Informal Document No. GRE-60-26
(60th GRE, 1 - 3 October 2008
agenda item 5(f))

ECE/TRANS/WP.29/GRE/2008/53-Rev1
11 July 2008

COLLECTIVE AMENDMENTS

Proposal for Supplement 3 to the 04 series of amendments to Regulation No. 48
(Installation of lighting and light-signalling devices)

FIGURE (see paragraph 6. 5.)

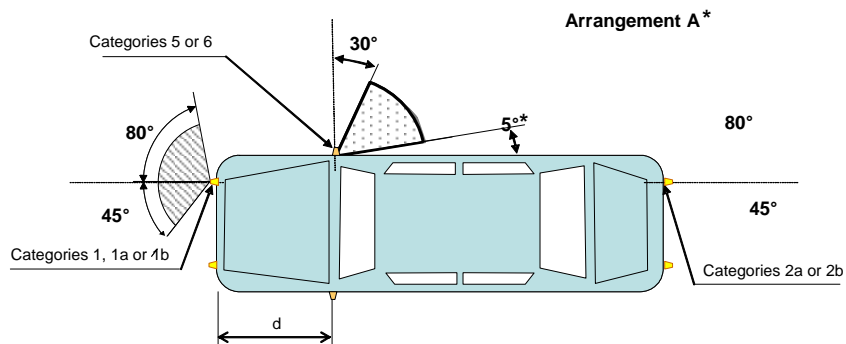
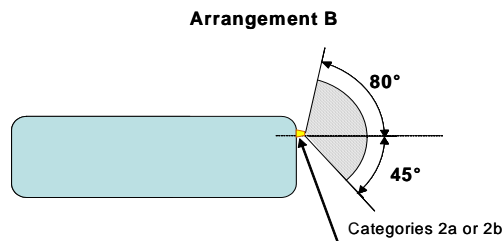
Paragraph 6.5.5.1., amend to read:

"6.5.5.1. Horizontal angles, (see figure below)

Vertical angles: 15° above and below the horizontal for direction-indicator lamps of categories 1, 1a, 1b, 2a, 2b and 5. The vertical angle below the horizontal may be reduced to 5° if the lamps are less than 750 mm above the ground; 30° above and 5° below the horizontal for direction-indicator lamps of category 6. The vertical angle above the horizontal may be reduced to 5° if the optional lamps are not less than 2,100 mm above the ground.

For M1 and N1 category vehicles, the value of 45° inward for the direction indicator lamps of categories 1, 1a or 1b, whose the lower edge of the apparent surface is less then 750 mm above the ground, may be reduced to 20° under the horizontal plan containing the reference axis of this lamp.

(*) The value of 5° given for dead angle of visibility to the rear of the side-direction indicator is an upper limit. $d \leq 1.80$ m(for M₁ and N₁ category vehicles $d \leq 2.50$ m)."

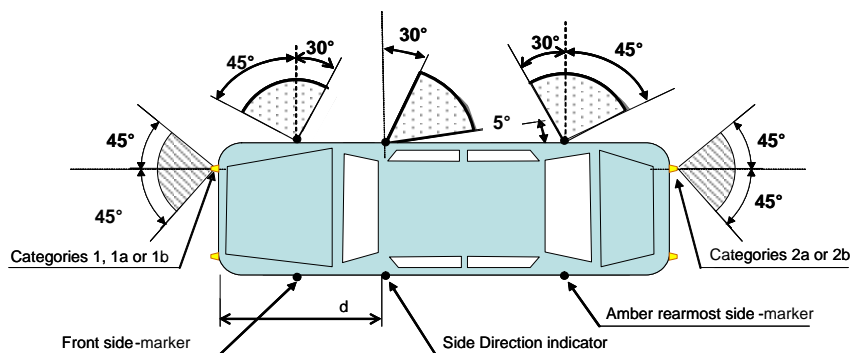
Paragraph 6.5.5.2., amend to read:

"6.5.5.2. or, at the discretion of the manufacturer, for M₁ and N₁ category vehicles (**):

Front and rear direction-indicator lamps, as well as side-marker lamps

Horizontal angles see figure below:

The value of 45° inward for the direction indicator lamps of categories 1, 1a or 1b, whose the lower edge of the apparent surface is less then 750 mm above the ground, may be reduced to 20° under the horizontal plan containing the reference axis of this lamp.

(**) The value of 5° given for dead angle of visibility to the rear of the side-direction indicator is an upper limit. $d \leq 2.50$ m."
